CITY OF ALBUQUERQUE

January 24, 2022

**RE: The Peaks by Markana
Grading & Drainage Plans
Engineer's Stamp Date: 01/05/22
Hydrology File: C18D088**

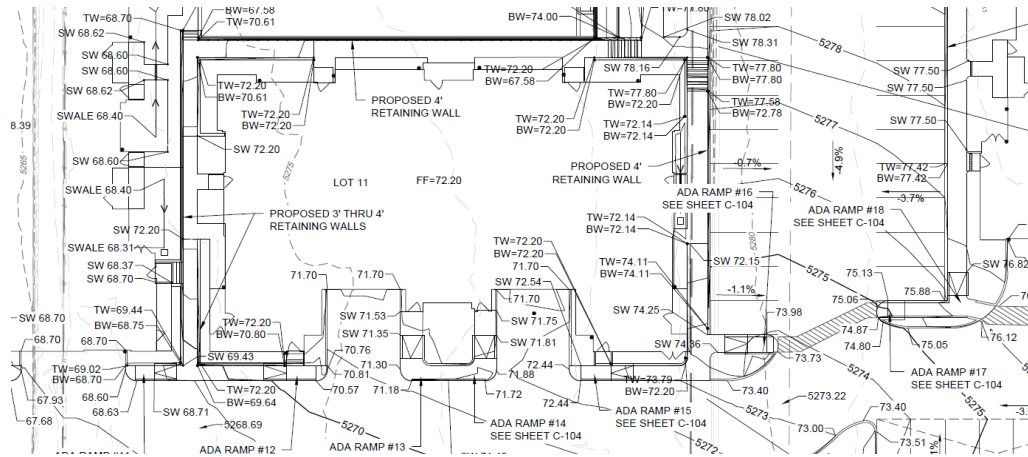
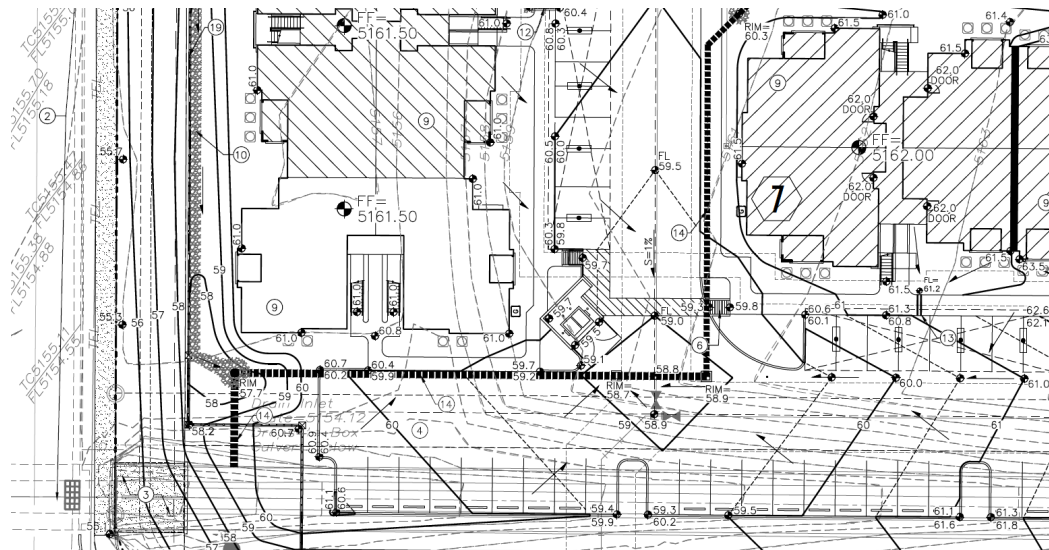
3. General Comment. Overall the Grading & Drainage Plan seems to lack clarity and is very busy. Also, there are line work missing such as the top of curb along the parking areas (currently it looks like there will be no curbing and it is just an edge of pavement).

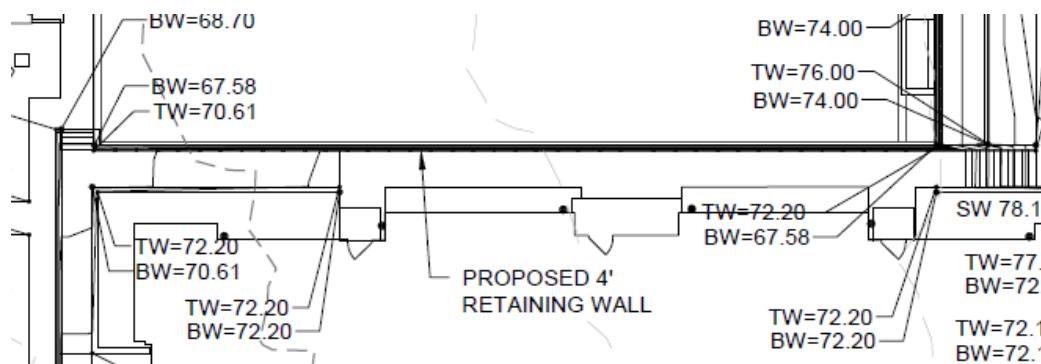
Here is an example of a similar project that has minimal spot elevation to get the job done.

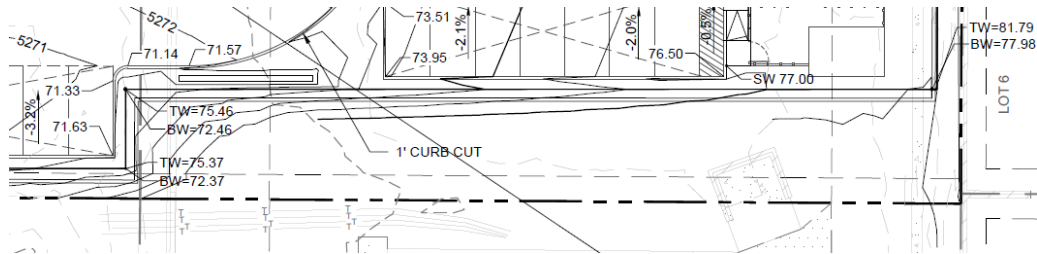
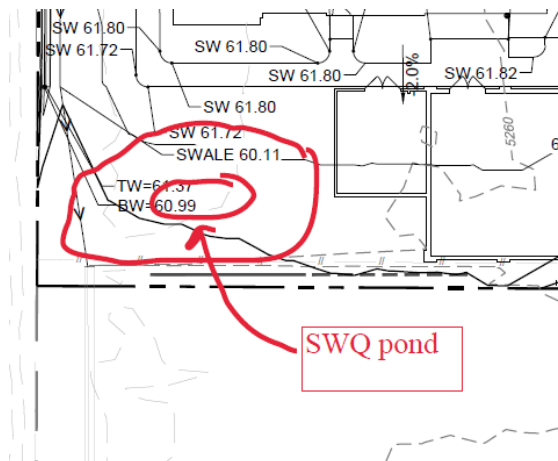
4. General Comment. Please place the retaining walls as a line type in the Legend. There seems to be different line work for retaining walls. Also, there are double lines (from the Architect?) that needs to be turned off.

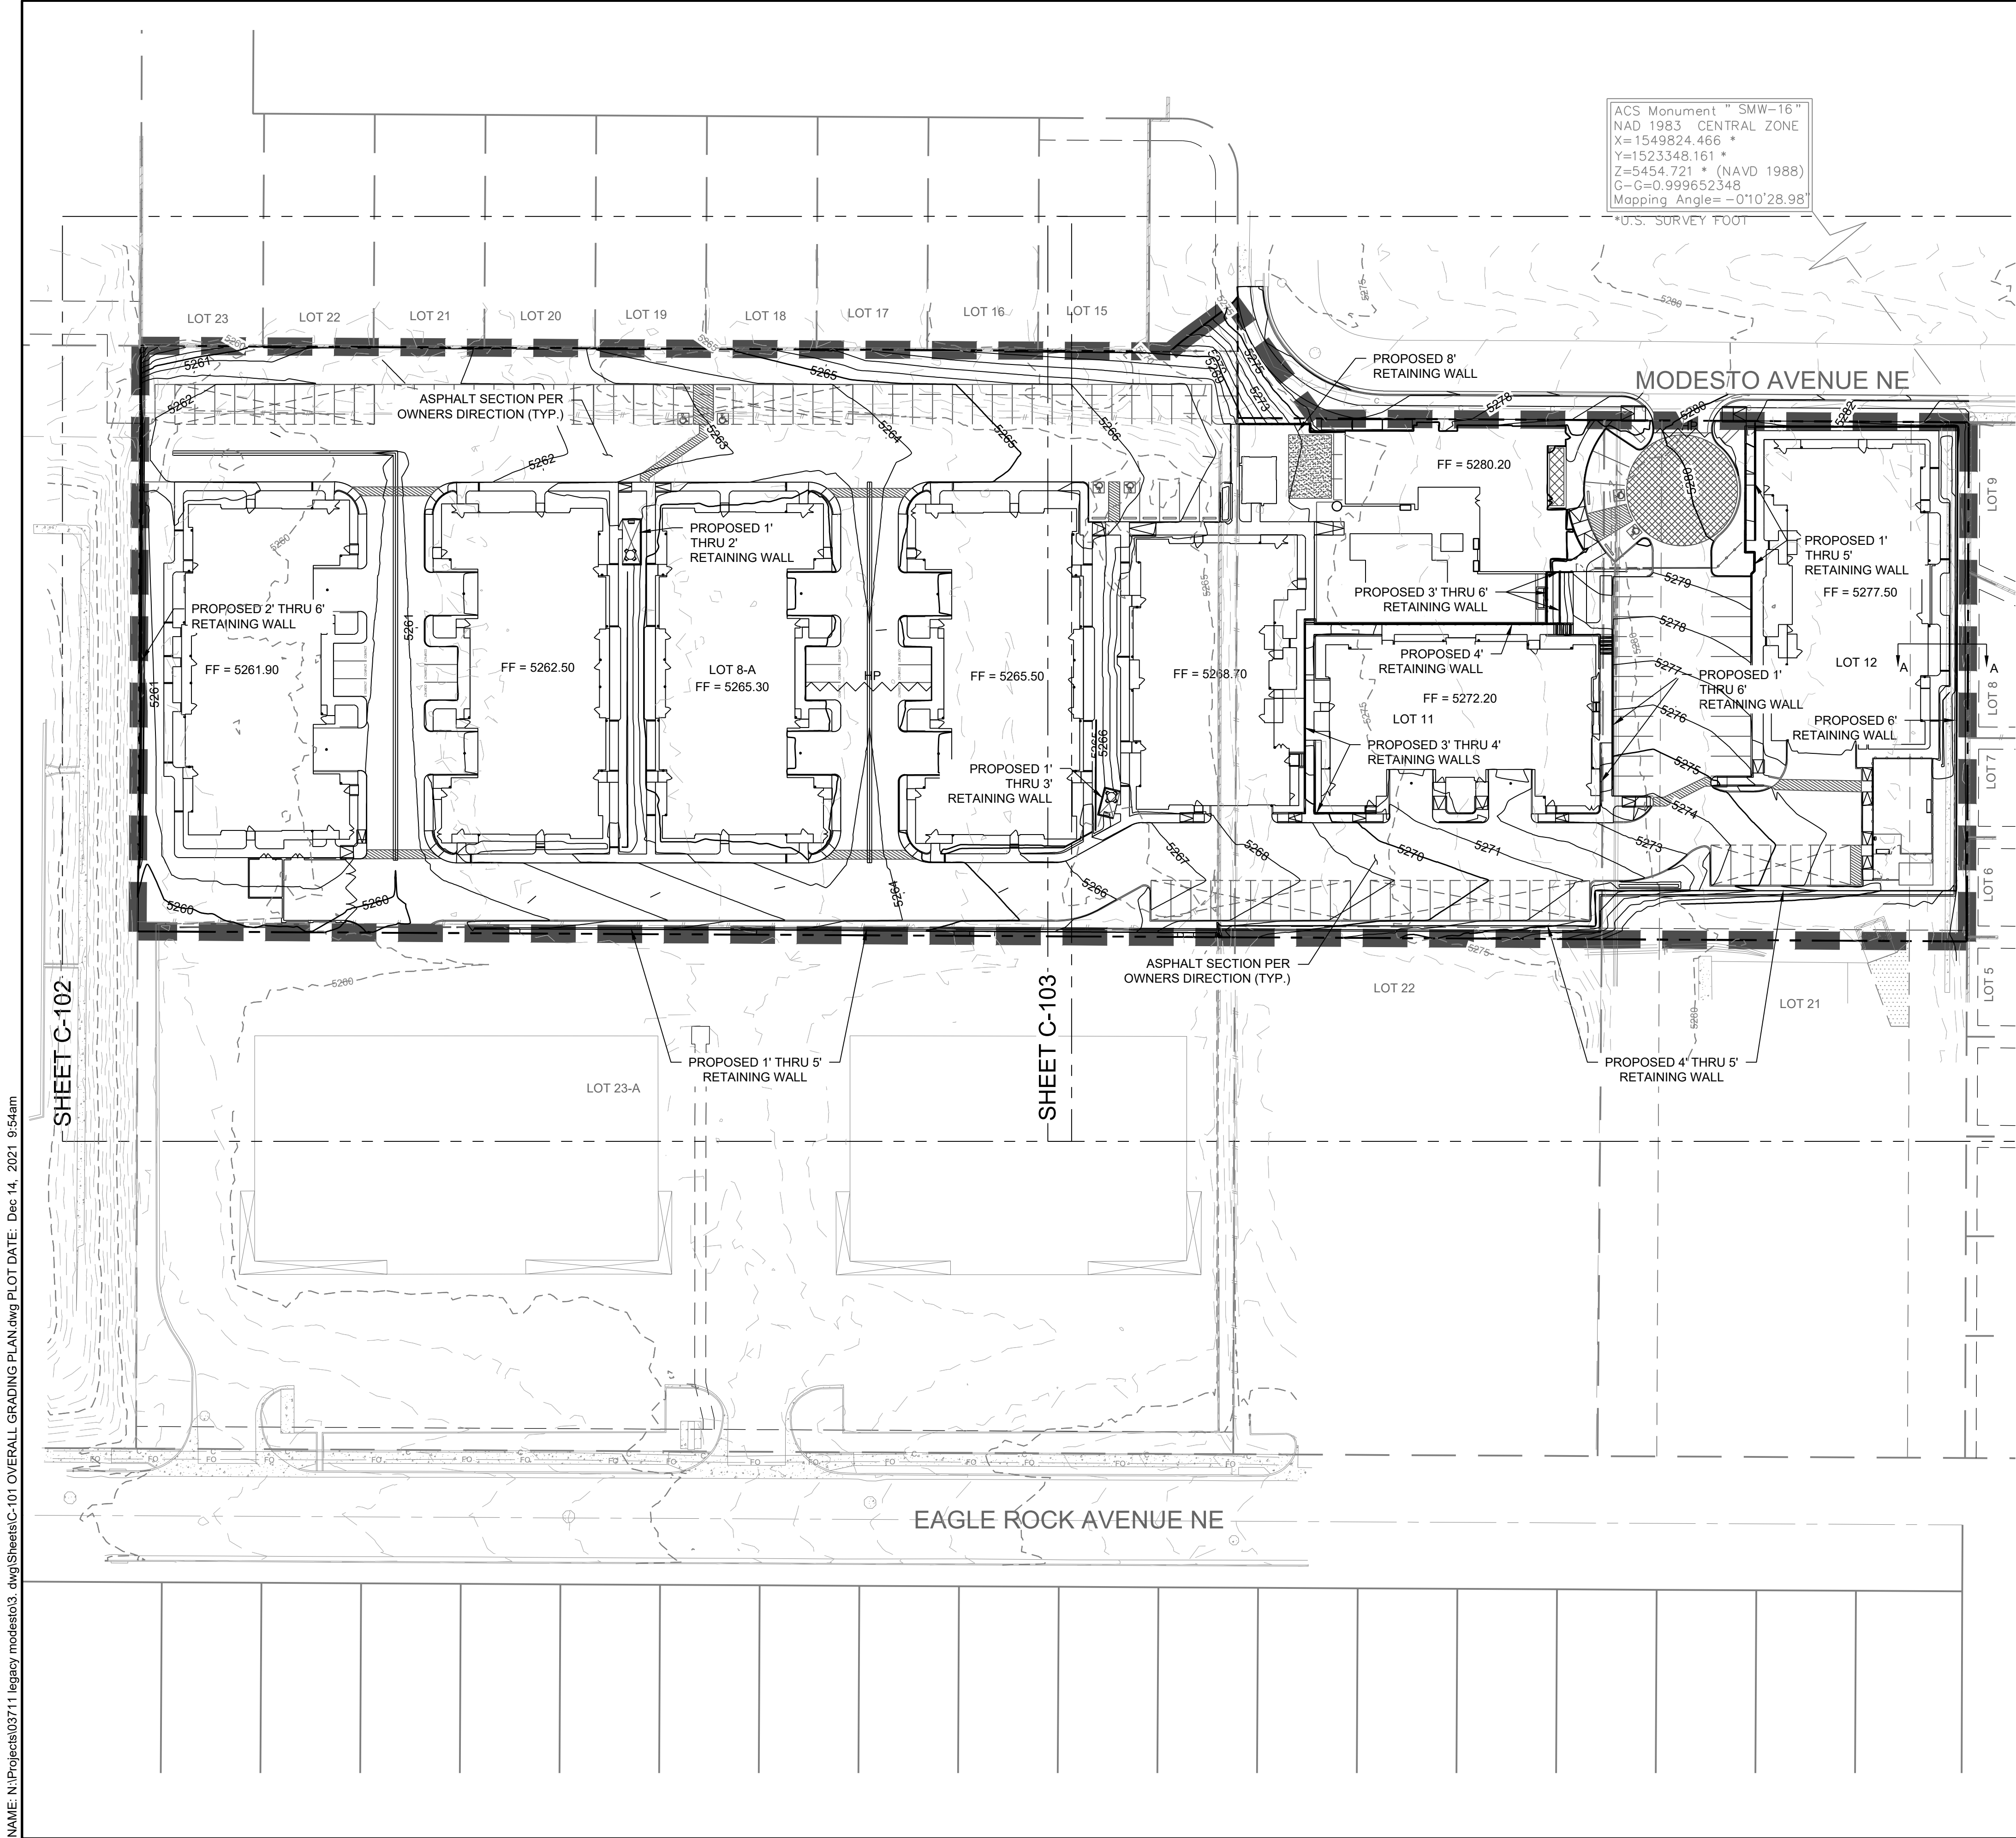
6. Sheet C101. Per the DPM, the following must be on the Grading Plan.
 - a. Please provide a Vicinity Map.
 - b. Please provide the Benchmark information (location, description and elevation) for the survey contour information provided.
 - c. Please provide the FIRM Map and flood plain note with effective date.
 - d. Please provide a legal Description of the property.
7. Sheet C100. Please show and calculate the amount of stormwater quality pond volume that was able to provide. Please use the attached Waiver form for the remainder of the volume.
